Access Compliance Report Public Rights-of-Way (Curb Ramps)

Main Street: DANA_POINT_HARBOR_DR Cross Street: PUERTO_PL Location: SW

ADA ID: RPRK220208145246 Ramp Type: Type 1 - Perpendicular Diagonal Initial Pass/Fail: Pass Overall Compliance: No Severity Score: 2

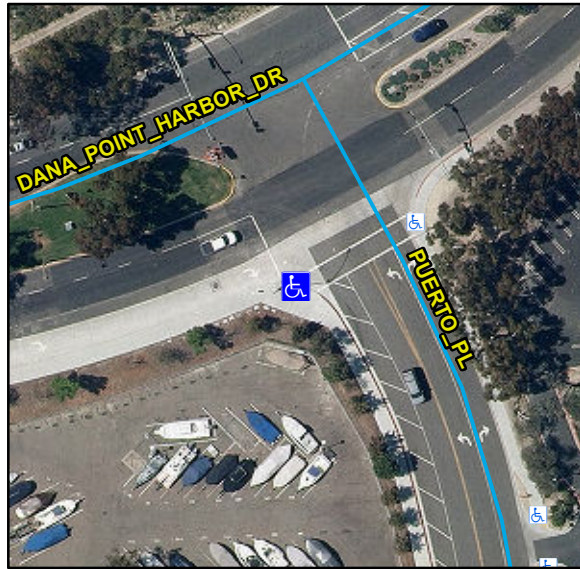
R304.2.3, STD 1115

Remove & Replace Curb Ramp With Two New Directional Ramps or Equivalent.
